## REVIEW COMMENT AND RESPONSE LOG

| <b>Project Title:</b><br>Glenwood Center |                                                | <b>Type of Review:</b><br>Design Review   |

DSRFY2026 – 0015; 4983, 5111 N. Glenwood St., and W Chinden Blvd.

DR area  
calcs  
**a3.90**

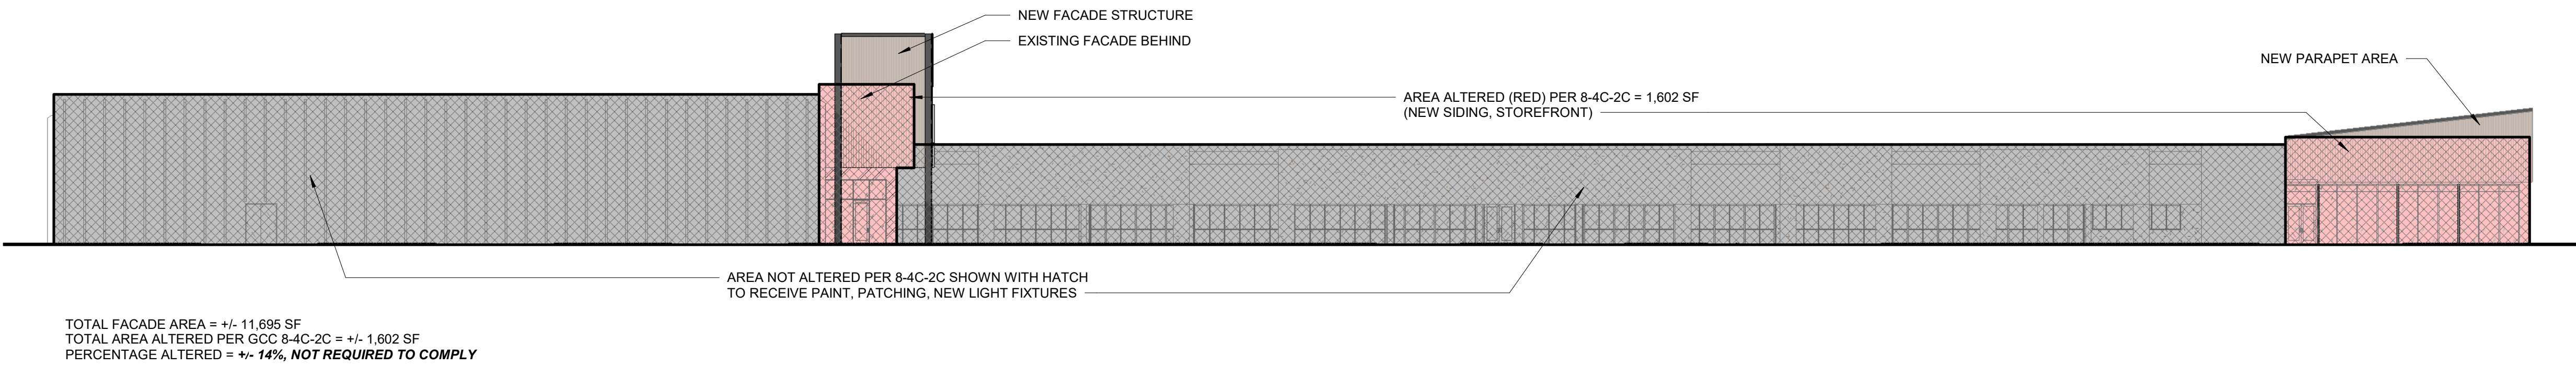
| 4 | 8-4C-3 | <p>A) "It is unclear whether the façade along Chinden Boulevard provides 30% of the required ground-floor activation elements."</p> <p>B) "The parking lot is in a preexisting location. The applicant provided an updated landscaping and parking design for the surface parking area. However, there is a missing landscape buffer along Glenwood Street that needs to be addressed."</p> <p>C) "Driveways are greater than 22 feet wide. The transportation agency did not provide comments at this time. Discussion is required."</p> <p>D) "May not be compliant."</p> <p>E) "An additional crossing may be required to serve this portion of the site"</p> <p>F) "Not provided" – entrance feature</p> <p>G) "Staff believes that the changes to the façade along Glenwood- specifically, the addition of more glazing in the pedestrian zone and the modification of the roofline— comply with the requirements of this section. However, staff is not certain that the façade along Chinden meets the requirements. "</p>                                                                                                                                                                                                                                                                                                                                                      | <p>A) See provided facade area calcs. Facade along Chinden less than 25% altered.</p> <p>B) Revised as noted. Screening has been provided in the indicated area.</p> <p>C) Striped walkways provided at driveways.</p> <p>D) Striped crossings provided throughout site.</p> <p>E) Revised as noted.</p> <p>F) The tot lot has been relocated near the entrance of the church. This includes the incorporation of bike racks, tables, seating, etc.</p> <p>G) See provided facade area calcs. Facade along Chinden less than 25% altered.</p> |

TOTAL AREA ALTERED PER GCC 8-4C-2C > 25%, **REQUIRED TO COMPLY**  
GCC 8-4C-3A4: **COMPLIES AS NOTED ABOVE**  
GCC 8-4C-3C: **COMPLIES AS NOTED ON ELEVATIONS**  
GCC 8-4C-3E: **COMPLIES AS NOTED BELOW**

C1.0

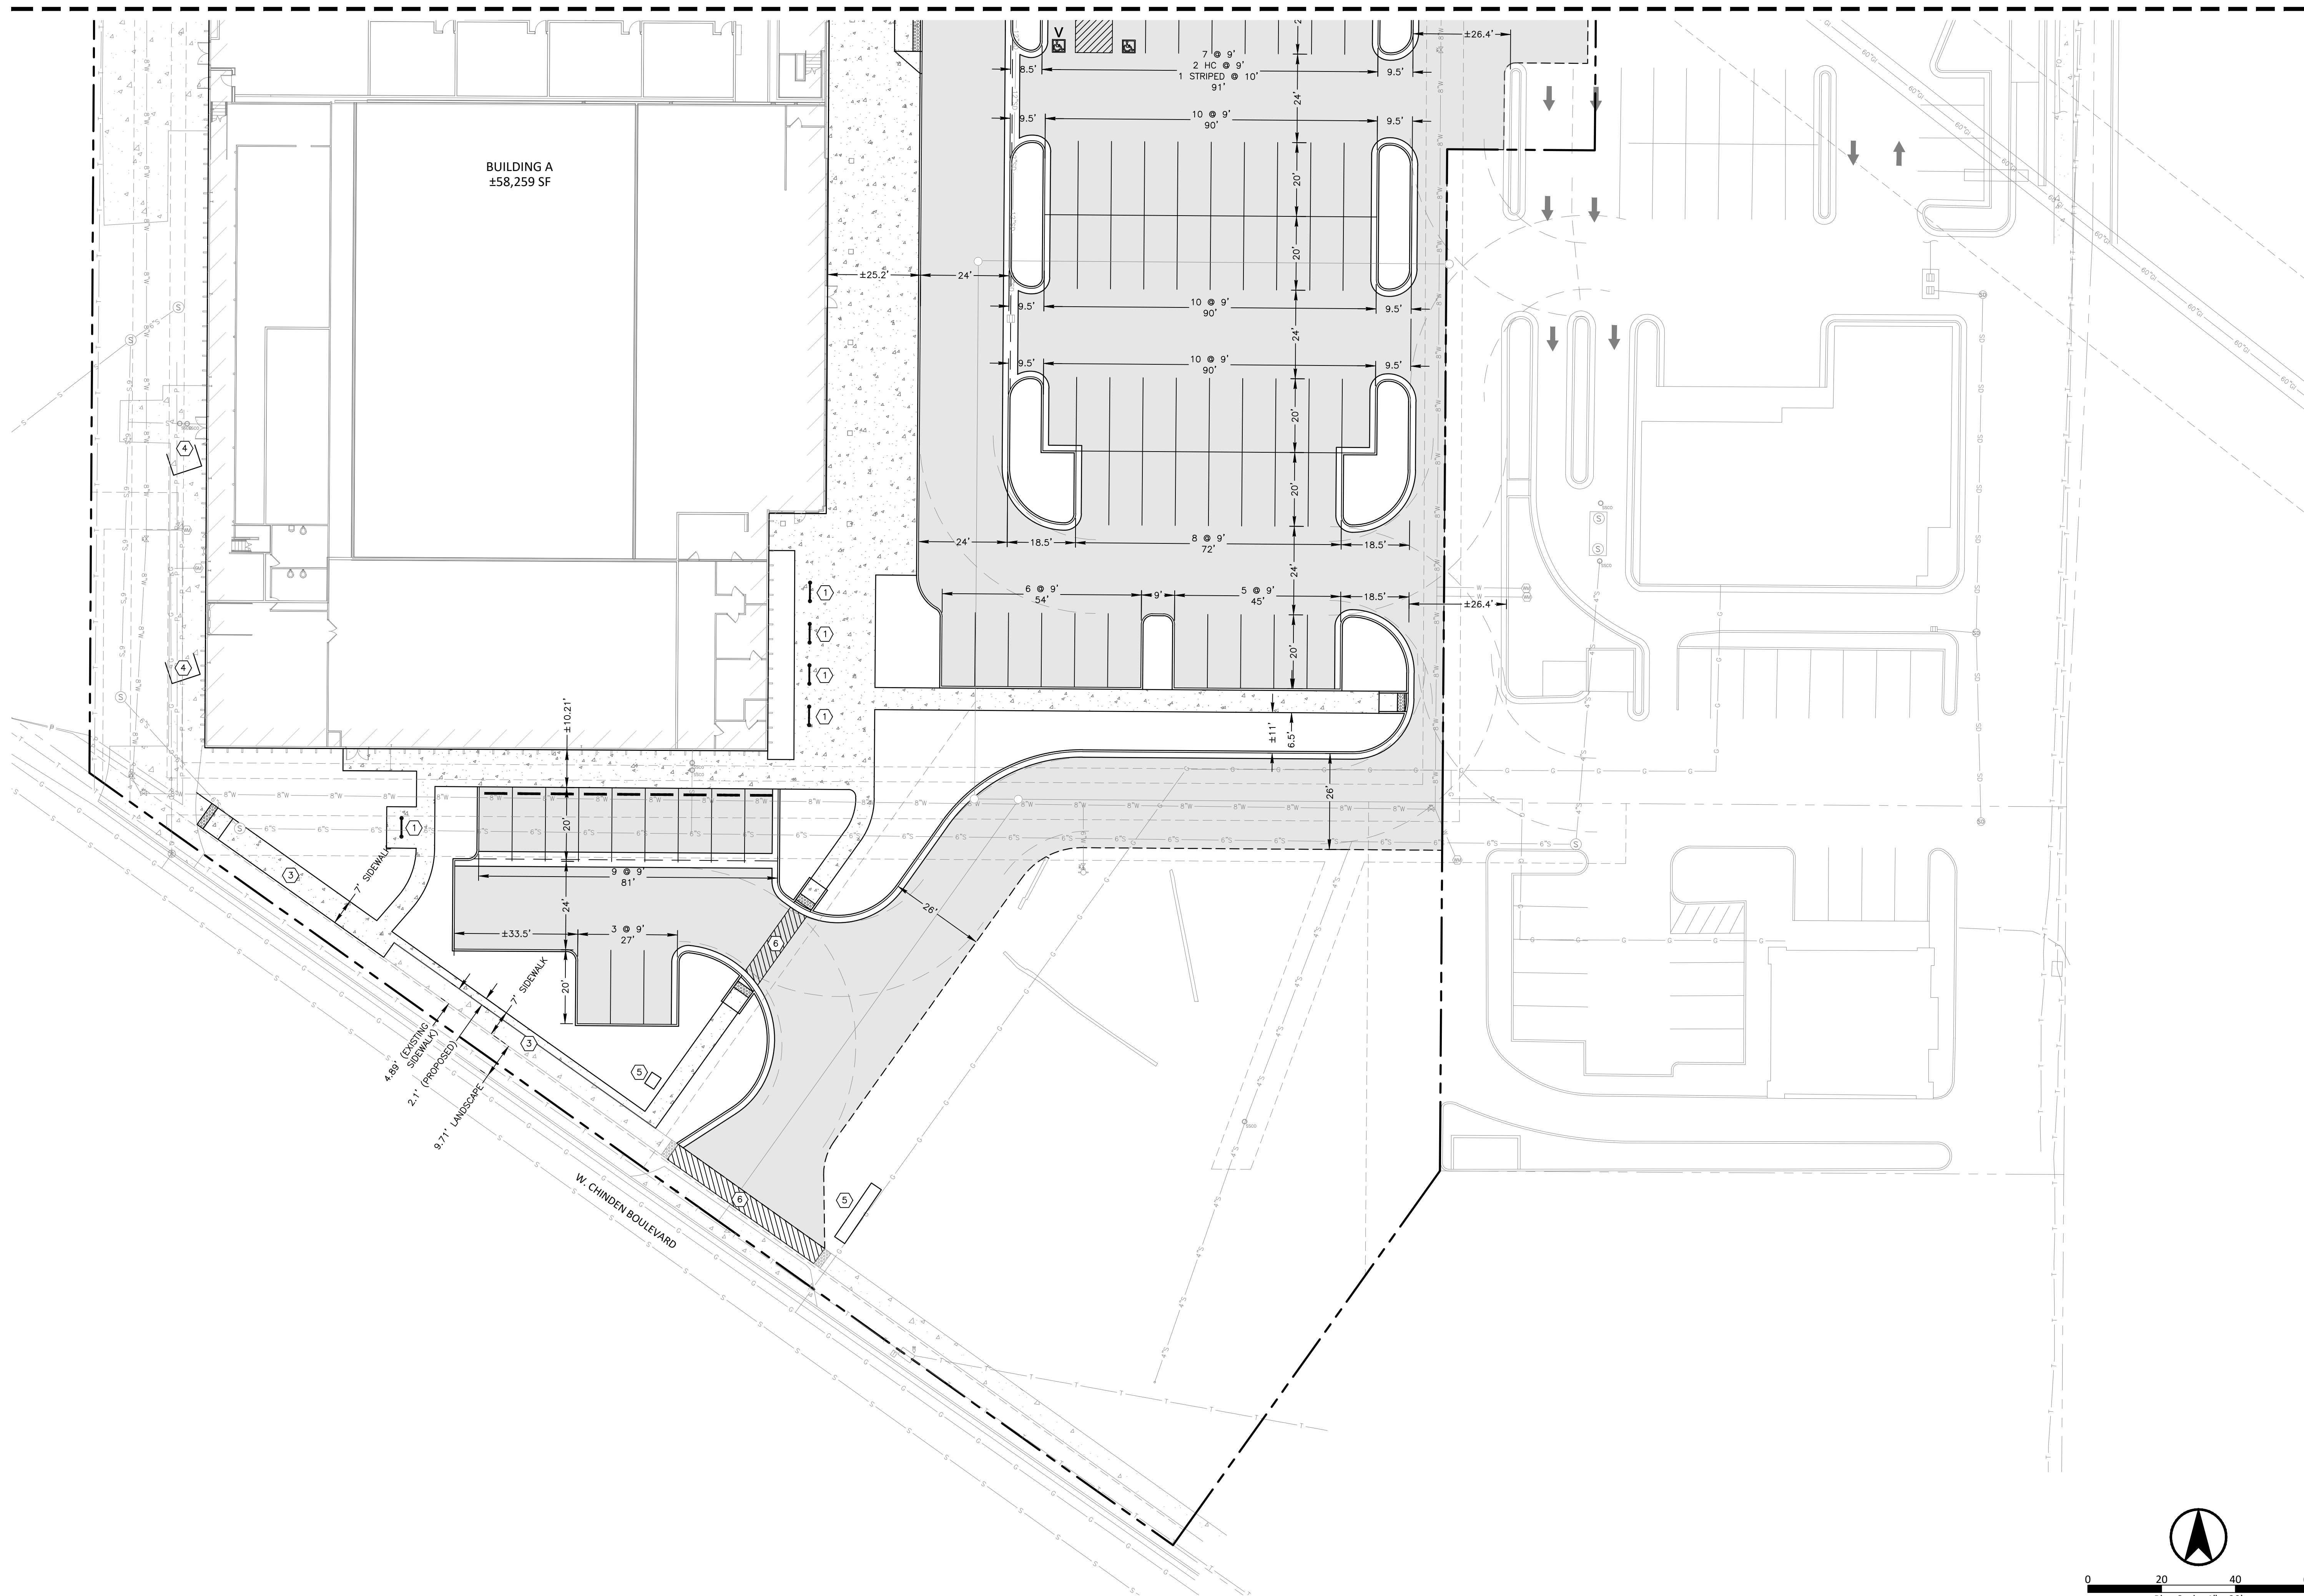
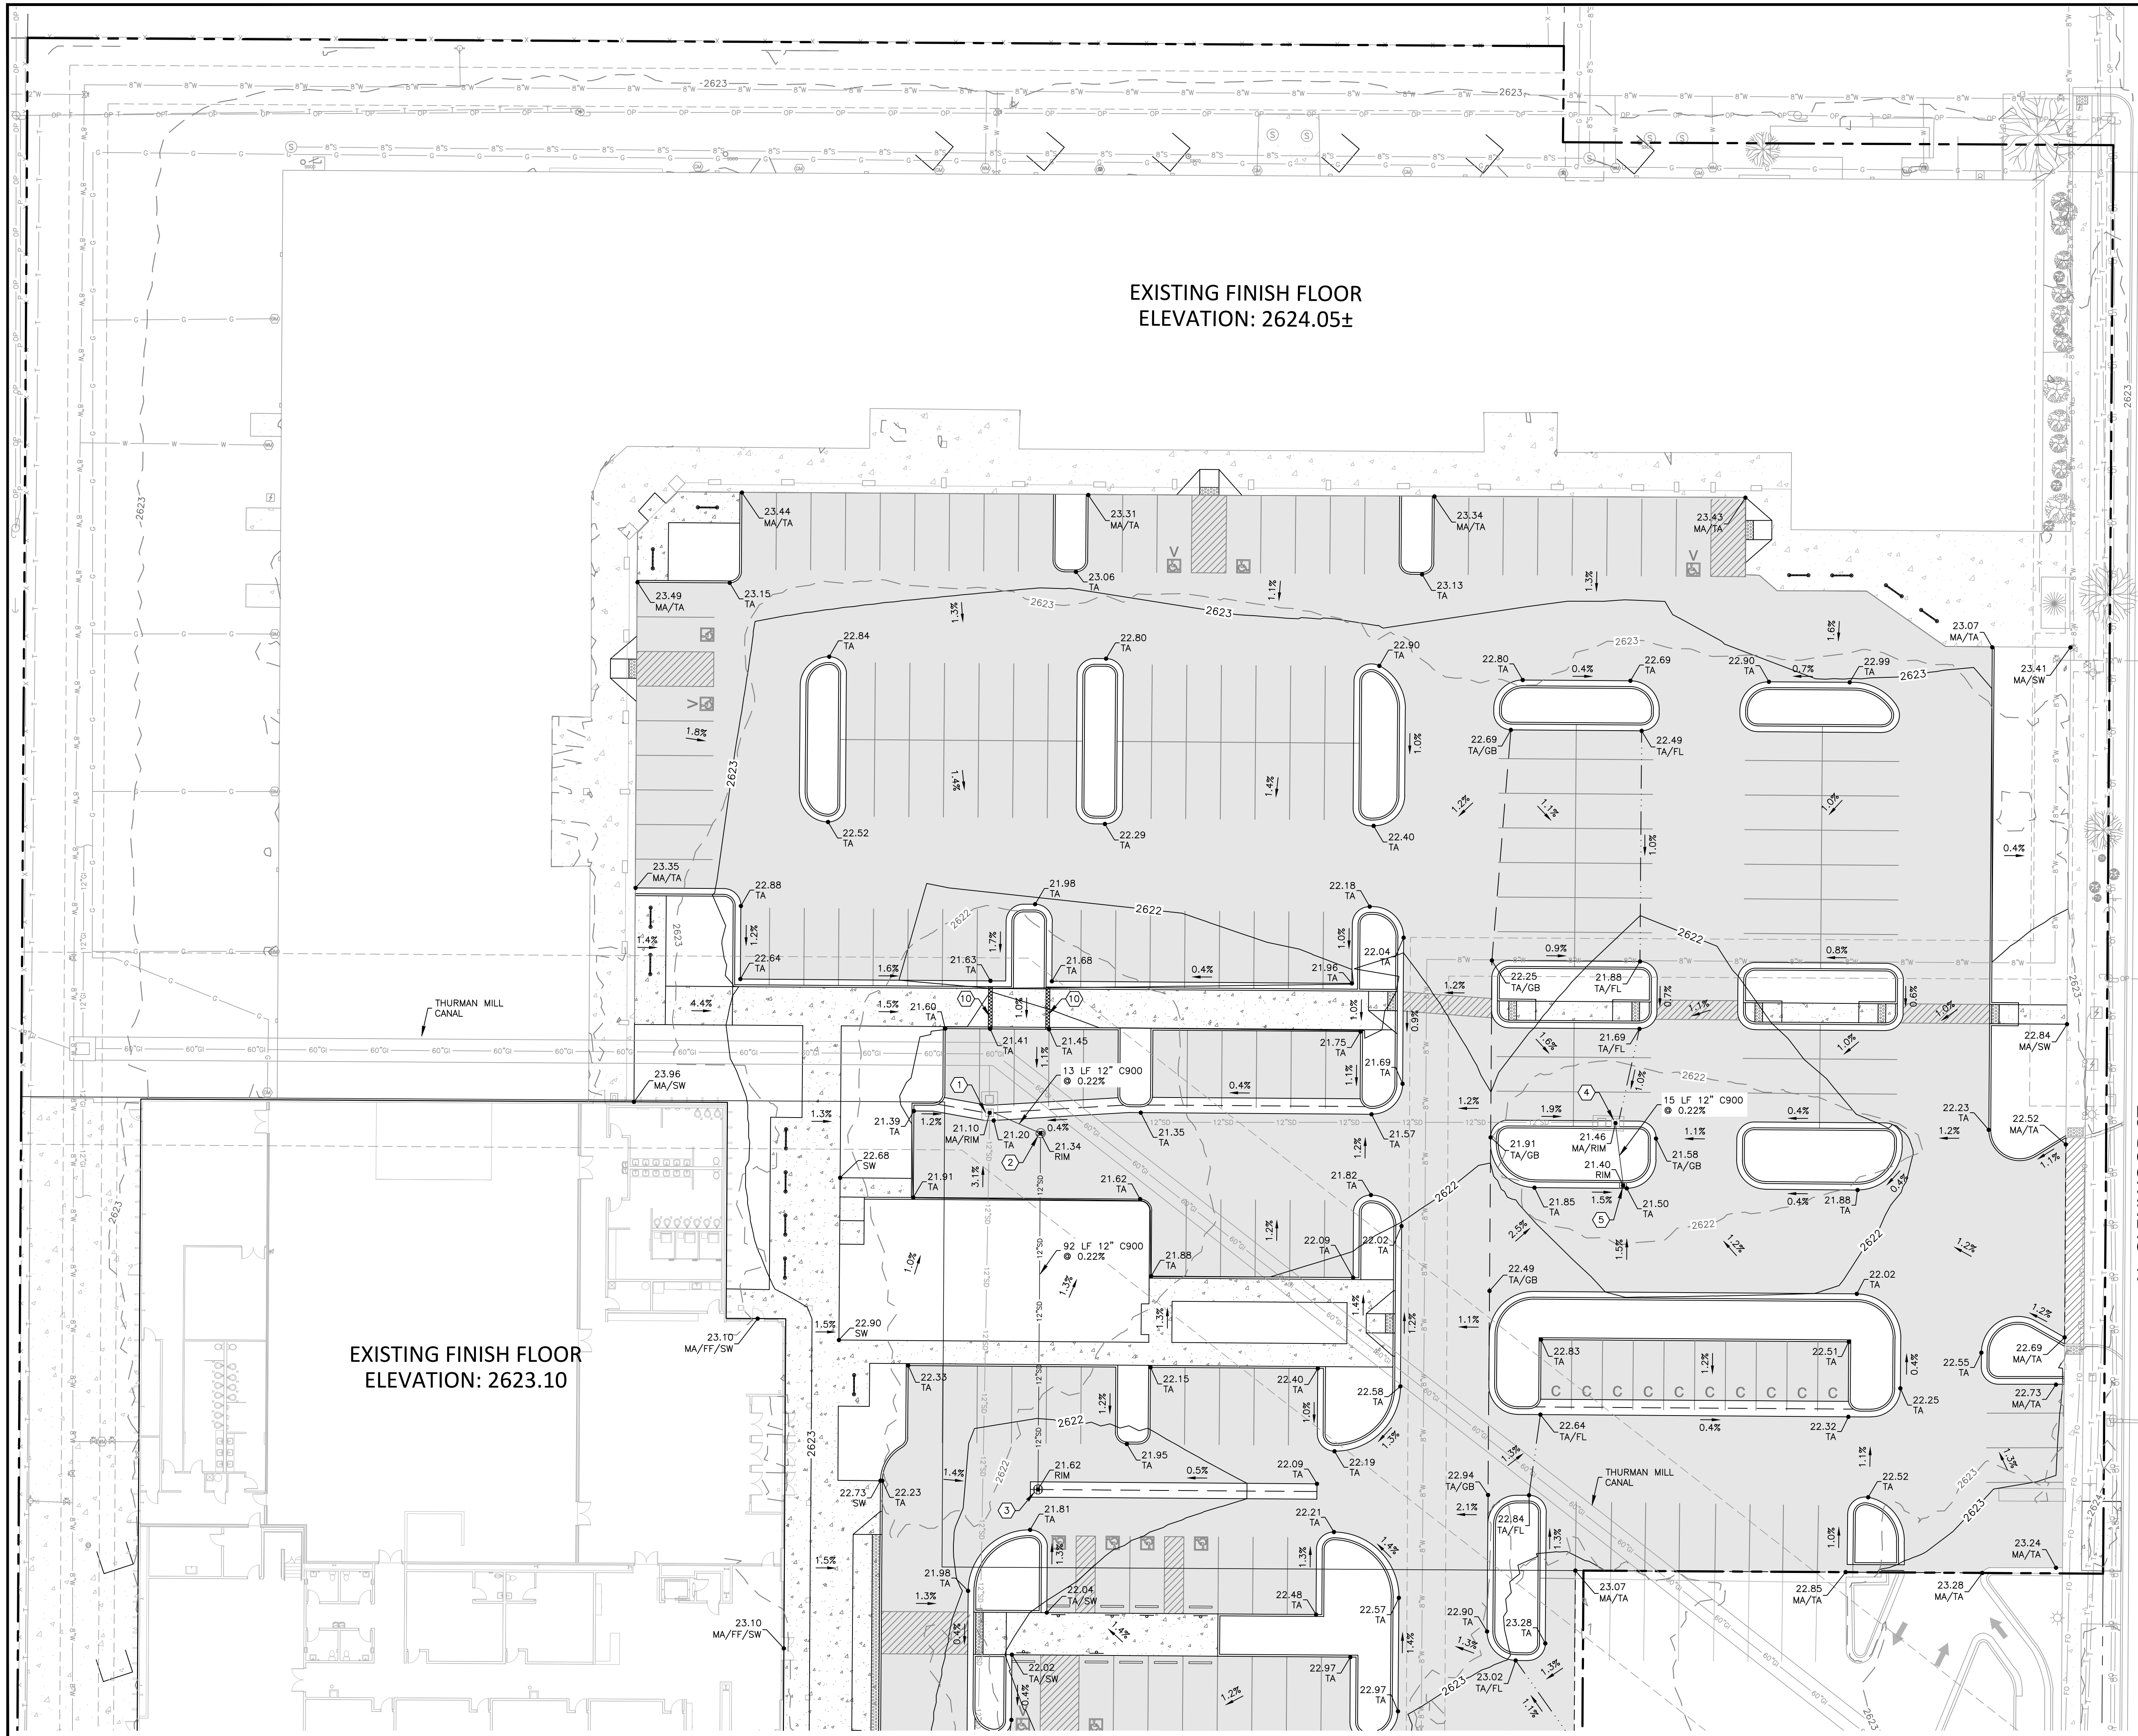
| 7  | 8-4E-6 | <p>“The applicant has incorporated these requirements into the plans for this application. However, the dimensions on the site plan are unclear. “</p> <div> <div>8-4E-6<br/>Sidewalk<br/>Standards</div> <div>May not be<br/>compliant</div> <div> <p>There is an existing detached sidewalk along Glenwood Street. Along Chinden Boulevard, there are both attached and detached sidewalks. A condition of approval in CUPPY2026-0001 required a 7-foot-wide detached sidewalk with a 5- to 7-foot furniture/planting zone along the street. The applicant has incorporated these requirements into the plans for this application. However, the dimensions on the site plan are unclear.</p> </div> </div>                                                                                                                                                                                                                                                                                                                                                                                                      | See entitlement site plan sheets C1.1 and C1.2 for site plan dimensions.                                                                                                                                                                                                        |
| 8  | 8-4E-7 | <p>“The dimensions on the site plan are unclear. “</p> <div> <div>8-4E-7<br/>Pedestrian<br/>and Bicycle<br/>Accessibility<br/>Standards</div> <div>May not be<br/>compliant</div> <div> <p>There are direct connections between the internal pathway and the sidewalk along both Chinden Boulevard and Glenwood Street. An additional pedestrian connection is also provided midway along the Glenwood frontage, connecting the sidewalk to the internal pathway.</p> <p>A pathway shall be a minimum width of four feet (4'). The dimensions on the site plan are unclear.</p> <p>Pedestrian amenities shall be provided along sidewalks and pathways to support defensible space, crime prevention, pedestrian comfort and accessibility.</p> <p>The pathway may be painted on asphalt; or be made of another material. The pathway shall be clearly for pedestrians. Suggested styles include crosswalk styles of either solid, continental, ladder, or zebra. Standard or dashed styles shall not be used.</p>  </div> </div> | See entitlement site plan sheets C1.1 and C1.2 for site plan dimensions.                                                                                                                                                                                                        |
